June 8, 2009
NND-09-0152

Subject: V. C. Summer Nuclear Station Units 2 and 3
Docket Numbers 52-027 and 52-028
Combined License Application – Environmental Report Audit
Information Needs: ACC-5 (Part 2), ALT-2 (Part 1), ALT-2 (Part 3), CR-19, and SW-14

VCSNS UNITS 2 and 3

Response to NRC Information Needs Item

Figure 1 Santee Cooper Region of Interest

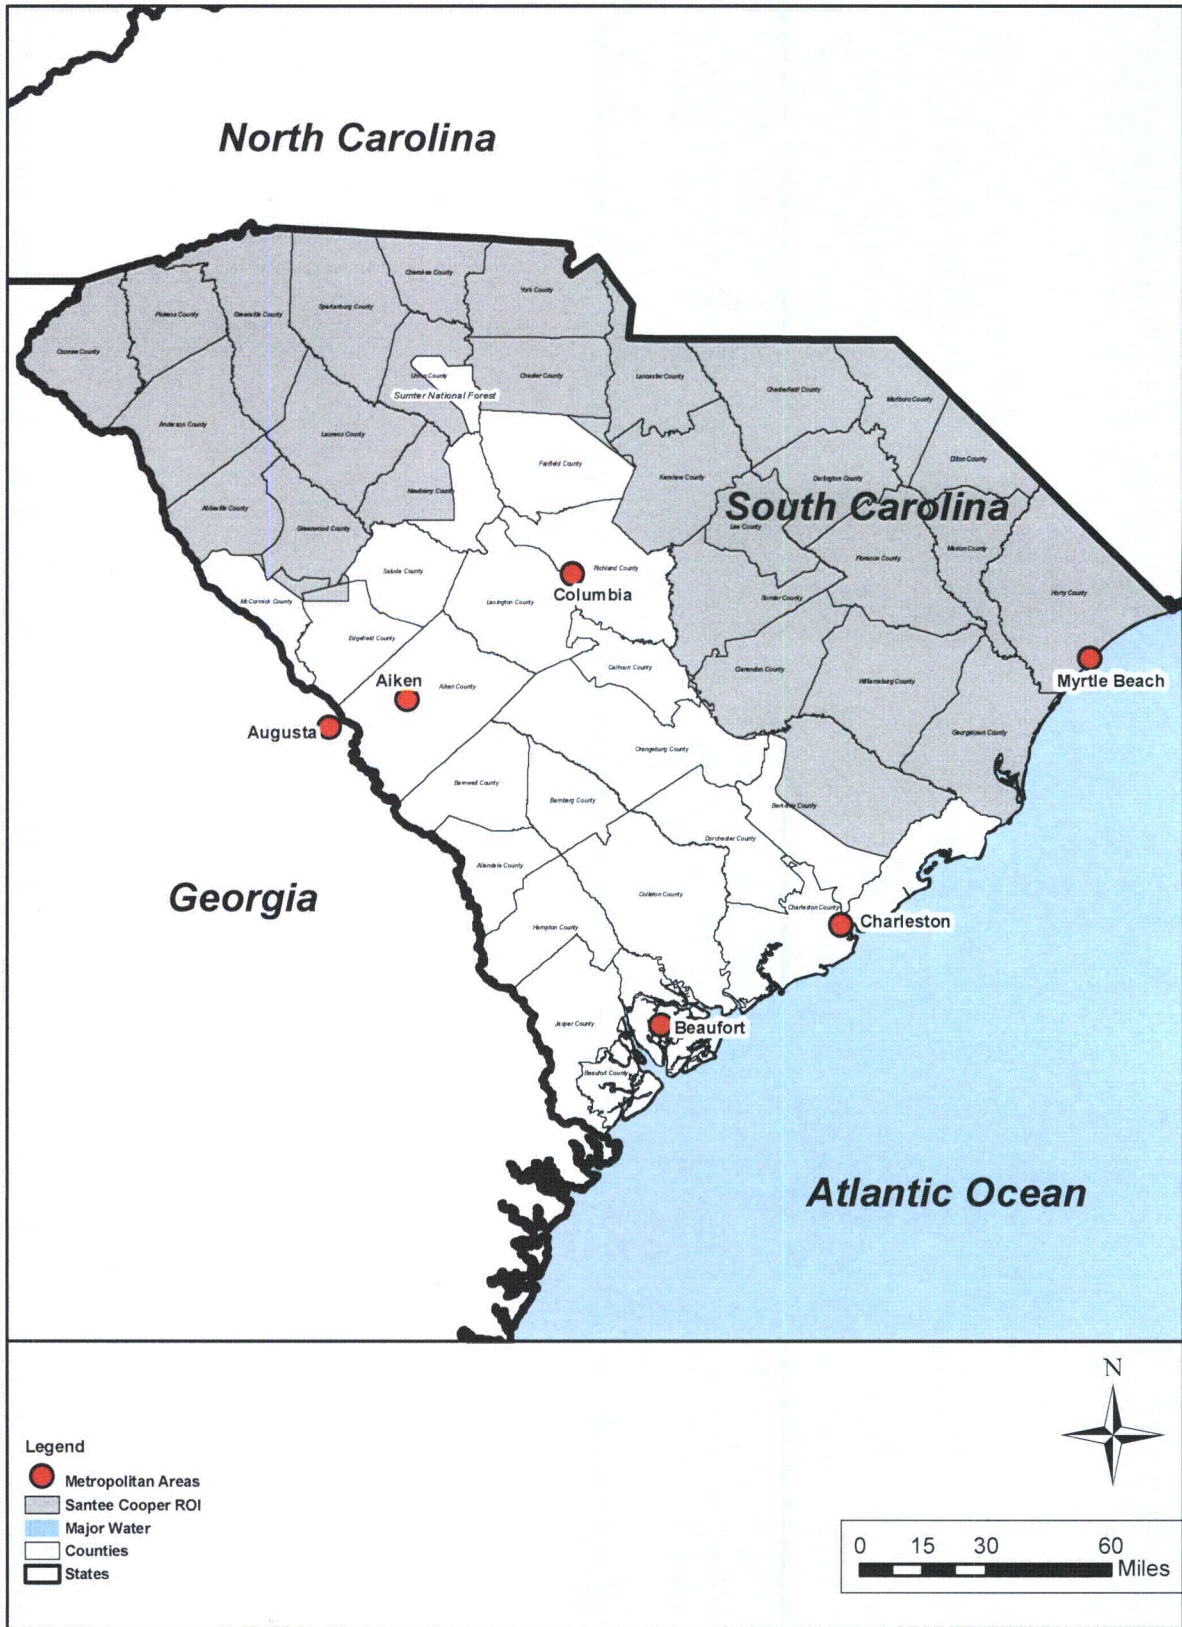
- How the ROI was clearly identified and screened to provide legitimate candidate sites (e.g., The ER identifies the state as being the ROI; the updated Jan. 2009 siting study focuses only on the SCEG service territory). Has this ever included the service territory of Santee Cooper?
- Derivation of weighting criteria used for potential site screening
- How the exclusionary and avoidance criteria were selected
- If any further analysis was, or should be, included regarding the reconnaissance level information as provided via the ER for either the proposed site or any of the three alternatives

1. Provide revised Section 9.3.2 redescrbing the ROI and how potential sites were identified
2. Provide analysis of additional alternative site FA-1 as a citable reference.
3. Provide information on the configuration of the proposed action on all of the alternate sites, to include power block, cooling tower(s), transmission line corridors, intake and discharge points, etc.

As requested by NRC, SCE&G reviewed the 22 South Carolina counties that are located outside the SCE&G service territory to determine whether the Santee Cooper service territory offers reasonable alternative sites in addition to those the SCE&G identified in its service territory. Attachment 1 presents the results of that review.

Consideration of the Santee Cooper service territory for alternative sites expands the VCSNS region of interest to the north and east of that limited to the SCE&G service territory. Because of how South Carolina service territories are laid out (see Figure 8.1-1), this expansion brings into consideration areas interspersed with service territories for Duke Energy and Progress Energy. Each of these utilities has performed siting studies and has identified alternative nuclear power plant sites. Santee Cooper has also performed siting work. Although the Santee Cooper siting was for fossil-fuel-fired plants, many siting considerations (e.g., cooling water supply, acreage availability, proximity to transmission lines) are common to fossil and nuclear plant siting.

Figure ALT-2-1 Possible Site Configuration for Fa-1 Site

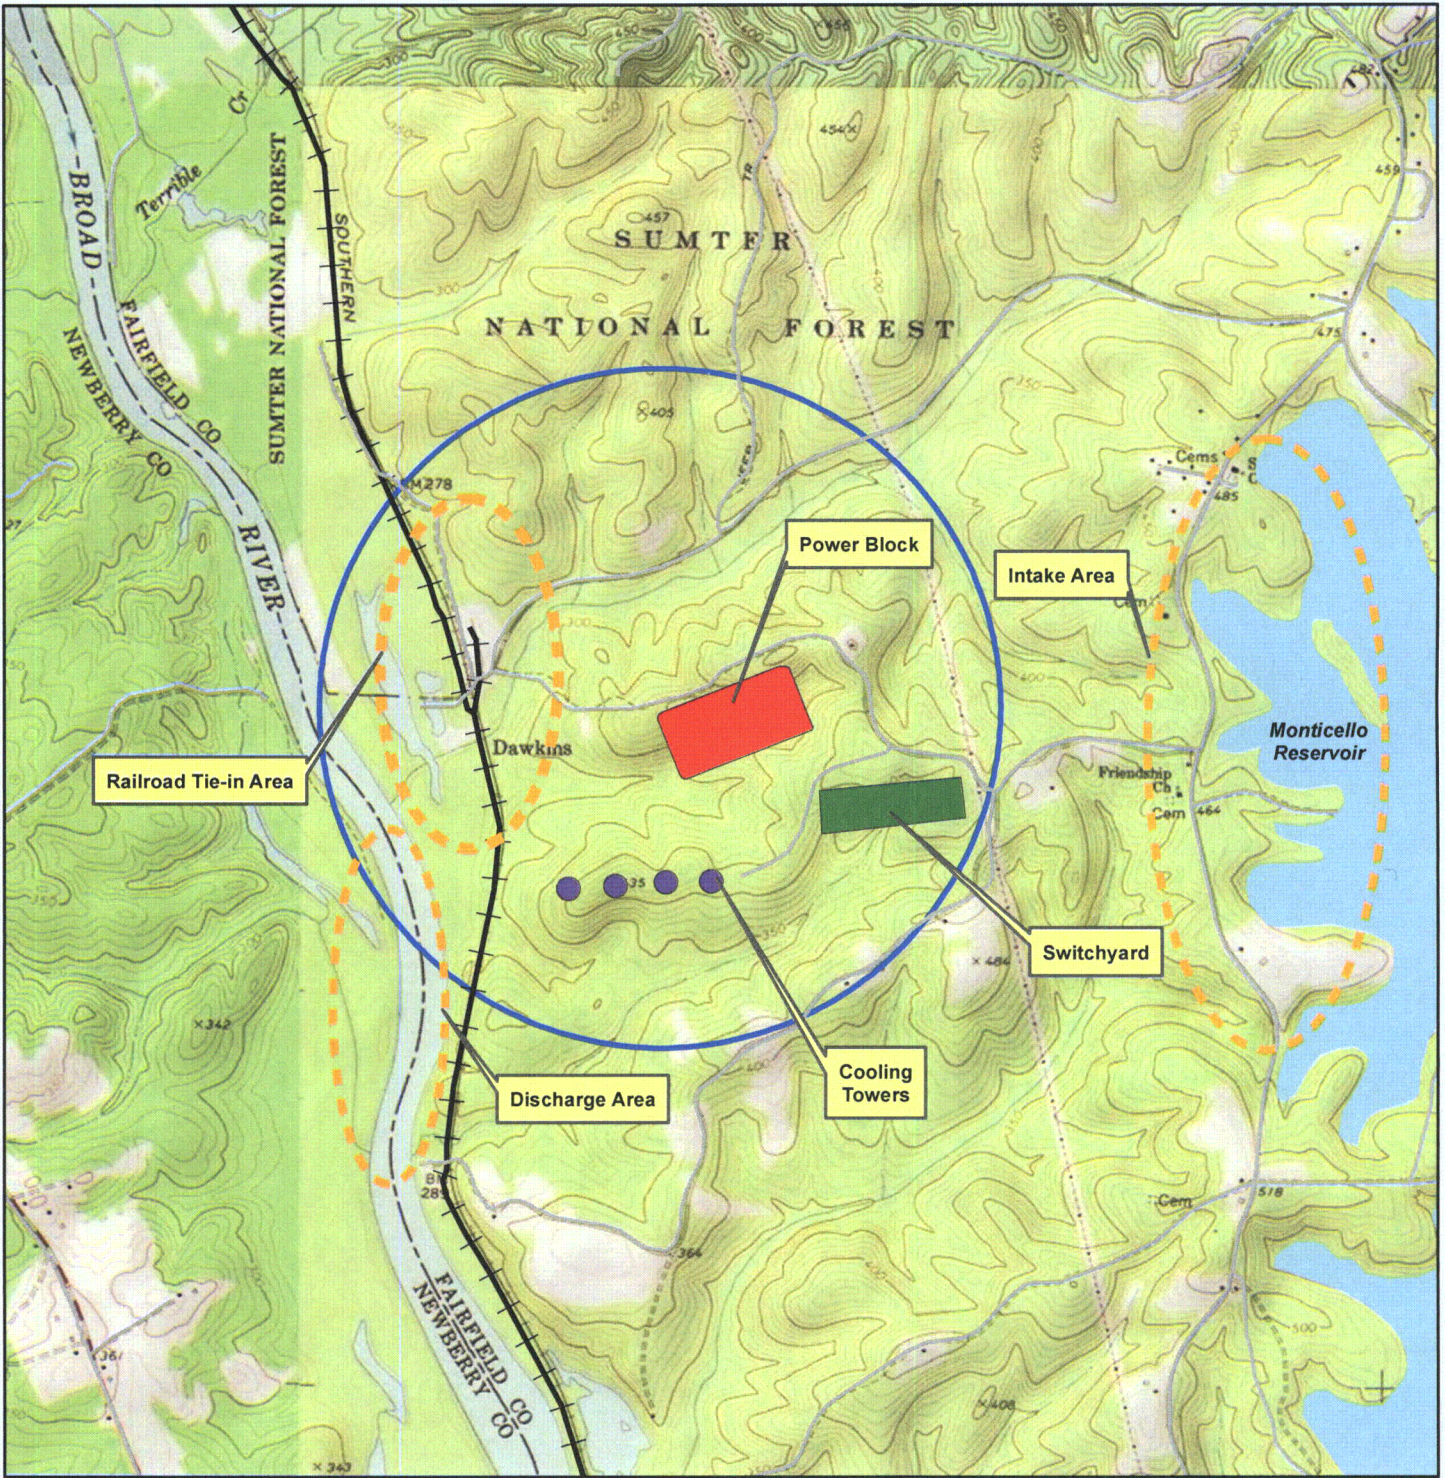
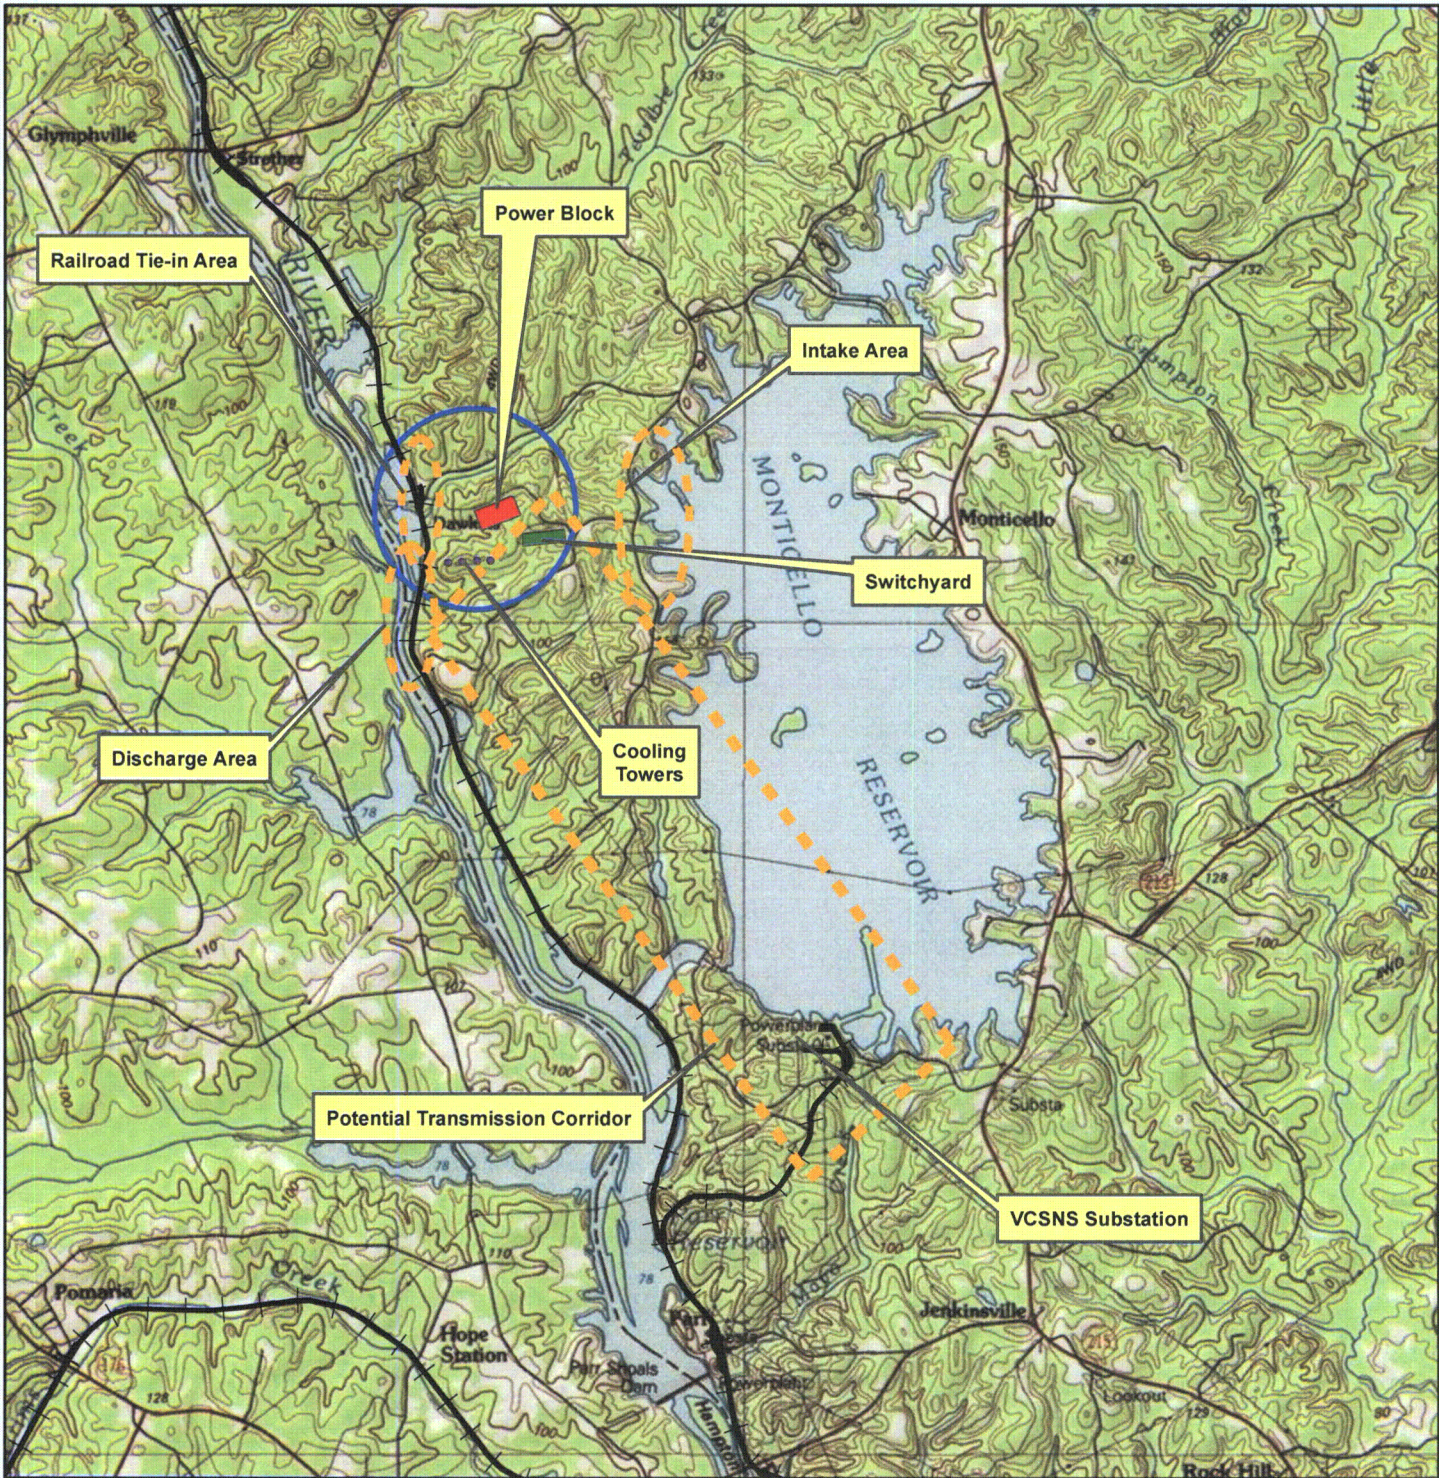
- How the ROI was clearly identified and screened to provide legitimate candidate sites (e.g., The ER identifies the state as being the ROI; the updated Jan. 2009 siting study focuses only on the SCEG service territory). Has this ever included the service territory of Santee Cooper?
- derivation of weighting criteria used for potential site screening
- How the exclusionary and avoidance criteria were selected.
- If any further analysis was, or should be, included regarding the reconnaissance level information as provided via the ER for either the proposed site or any of the three alternatives.

1. Provide revised Section 9.3.2 redesccribing the ROI and how potential sites were identified
2. Provide analysis of additional alternative site FA-1 as a citable reference.
3. Provide information on the configuration of the proposed action on all of the alternate sites, to include power block, cooling tower(s), transmission line corridors, intake and discharge points, etc.

SCE&G developed representative figures (attached) to show how the proposed action could be configured at each of the four alternate sites. The figures were developed using reconnaissance level information (i.e., information or analyses that can be retrieved or generated without performing site-specific investigations). If SCE&G or some other entity chose to construct a new nuclear generation facility at one of the alternate sites, a number of site-specific investigations (e.g., cultural resources survey, threatened and endangered species surveys, geotechnical investigations, etc.) would be required before the ultimate site configuration could be determined.

Figures ALT-2-1 and ALT-2-2 show a potential plant configuration and transmission corridors for the Fa-1 site.
